Product Change Notification / NTDO-09RUGQ249

CCB 4645 Final Notice: Qualification of MPHL as additional final test site for selected ATSAMA5D3xA device families available in 324L LFBGA (15x15x1.4mm) package.

QUALIFICATION REPORT SUMMARY

CCB 4645
Pre and Post Change Summary
PCN #: NTDO-09RUGQ249

Carrier Tape for T/R

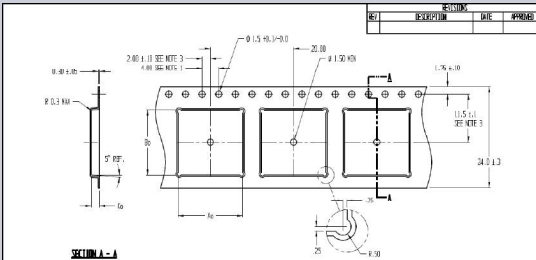
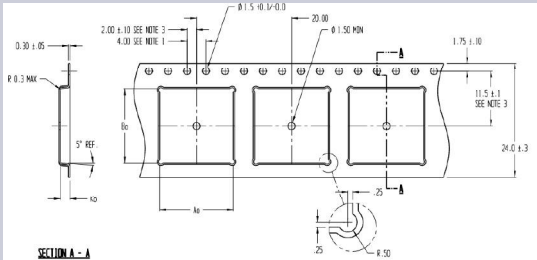
| Final Test Site | | ASE-Shanghai (ASSH) | ASE-Shanghai (ASSH) | Microchip Technology Operations (Philippines) Corporation (MPHL) |
|------------------------------|-----------|--|---------------------|--|
| Carrier Tape | | No dimensional changes* | | |

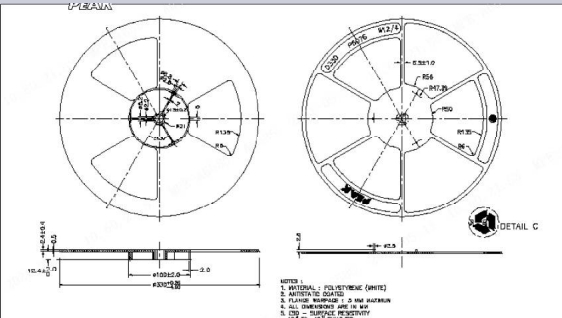
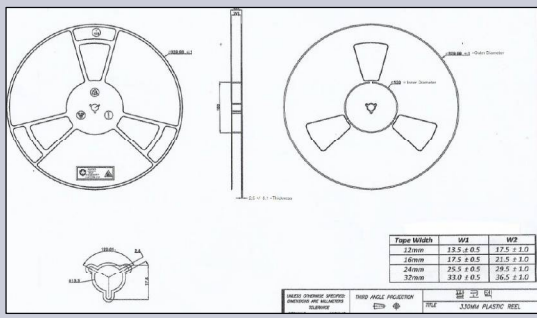
| Final Test Site | | ASE-Shanghai (ASSH) | ASE-Shanghai (ASSH) | Microchip Technology Operations (Philippines) Corporation (MPHL) |
|------------------------------|-----------|--|---------------------|--|
| Cover Tape | | Minor dimensional changes* | | |

| Final Test Location | ASSH | MPLH | | | | | | | | | | | | | | | | | | | | | | | | | | | | | | | | | | | | | | | | | | | | | | |
|---------------------------|---|------------------------------------|--------------------|---------------------|------|--------------------|------------------|--|---------------|-------------------|---------------------|------------------|-------------|-------------------------|----|------|----|---|---------------------------|--------------------|--------------------------|-----|---|-------|-----|----|-------|-----|----|-------|------|----|-------|------|----|--------|------------|----|--------|------|----|--------|------|----|--------|------|----|--------|
| | <table><tr><th>Width W (mm.)</th><th>Thickness T (mm.)</th><th>Sealing Methodology</th></tr><tr><td>21.3</td><td>0.048-0.058</td><td>Heat Active Type</td></tr></table> | Width W (mm.) | Thickness T (mm.) | Sealing Methodology | 21.3 | 0.048-0.058 | Heat Active Type | <table><tr><th>Width W (mm.)</th><th>Thickness T (mm.)</th><th>Sealing Methodology</th></tr><tr><td>21.3</td><td>0.045-0.055</td><td>Pressure Seal Activated</td></tr></table> | Width W (mm.) | Thickness T (mm.) | Sealing Methodology | 21.3 | 0.045-0.055 | Pressure Seal Activated | | | | | | | | | | | | | | | | | | | | | | | | | | | | | | | | | | |
